- A. MCM 120-thru-888 Shift Cutout Switch Adjustment
- B. MCM 120-thru-888 Shift Improvement Kit (B-65037A1)
- C. MCM 120-140-165 Shift Cable Damage Prevention
- D. MCM 215E and 215H Bell Housing Gasket Installation
- E. MCM 215E Shift Actuator Assembly (B-54240A5) Exchange - Reprint

**A. MCM 120-thru-888 SHIFT CUTOUT SWITCH ADJUSTMENT**

**Figure 1. Cutout Switch Adjustment**

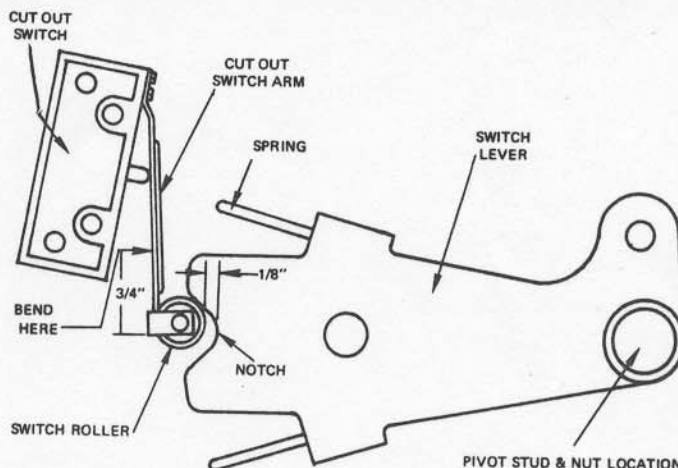
The shift cutout switch MUST BE operating and adjusted to cut out the ignition momentarily during stern drive unit shifting. This relieves the torque load on the sliding clutch in the gear housing. The lever that actuates the switch senses the control shift cable movement to accomplish this action. If a shifting problem exists after the shift cable installation and adjustment procedures (outlined in the MerCruiser Service Manual) had been properly accomplished, adjust cutout switch as follows:

1. Clean and lubricate the cutout switch assembly.
2. Loosen pivot nut (if tight) and lubricate shift lever pilot stud with Multi-purpose Lubricant (C-92-49588) to ensure that the switch arm roller returns freely to center of notch.
3. Connect switch leads to continuity meter.
4. Move switch lever slowly by hand and note roller position in lever notch when circuit is closed. (Figure 1) Switch roller should not be more than

1/8" (3.2mm) from bottom of notch. If more than 1/8", bend switch arm at a point approximately 3/4" (19mm) from end toward the bottom of the notch to obtain a closed circuit within 1/8" from bottom of notch.

Figure 2. Flywheel Clamp Location

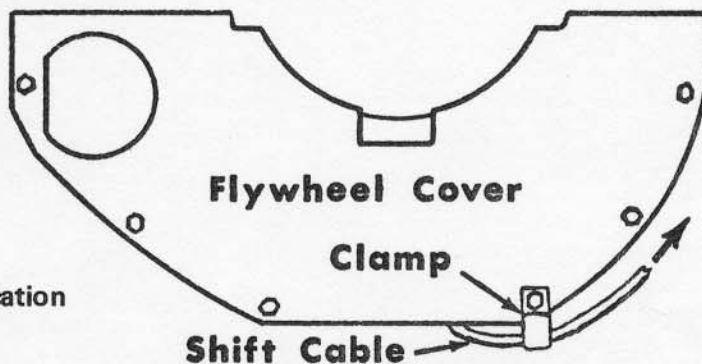
Under certain conditions during severe boat operation, the MCM 120-140-165 stern drive shift cable could become damaged between the gimbal housing exhaust elbow and the engine flywheel housing, making it inoperative. As a precaution, keep the shift cable away from this area. Install clamp (C-54-52923) on the engine flywheel housing cover and route the shift cable through the clamp. (Figure 2) Remove screw from the bottom left side of the flywheel cover and replace it with screw C-10-26065, fastening the clamp (C-54-52923) in a vertical position. The stern drive unit shift cable **MUST BE** routed through the clamp horizontally.
